Revised Proposal of amendments to ECE/TRANS/WP.29/GRSP/2014/11 - Draft Regulation on electric vehicles of category L, submitted by the Informal Working Group REESS

Submitted by the expert from the International Motorcycle Manufacturers Association

The text reproduced below was prepared by the expert from the International Motorcycles Manufacturers Association (IMMA) to introduce amendments clarifying the current text and correcting some of the text to what was agreed in the Informal Group RESS, **for discussion in 12/IWG RESS meeting.**

Figure 1

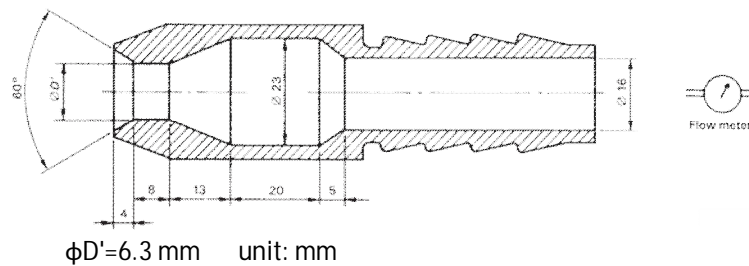
- (vii) distance from nozzle to enclosure surface: between 2.5 m and 3 m.
- (b) subsequently, apply 500V DC ~~between all the inputs and the vehicle's exposed conductive parts including the electrical chassis~~ **between all high voltage inputs and the vehicle's exposed conductive parts/electrical chassis** if present to measure the insulation resistance."

Some low voltage vehicle inputs are not directly connected to the REESS and may have a galvanic connection to the vehicle chassis (i.e. – 12V ground circuits) and should not be included in this test. The test is intended to assess protection against ingress of water and its potential effect on the High Voltage bus.
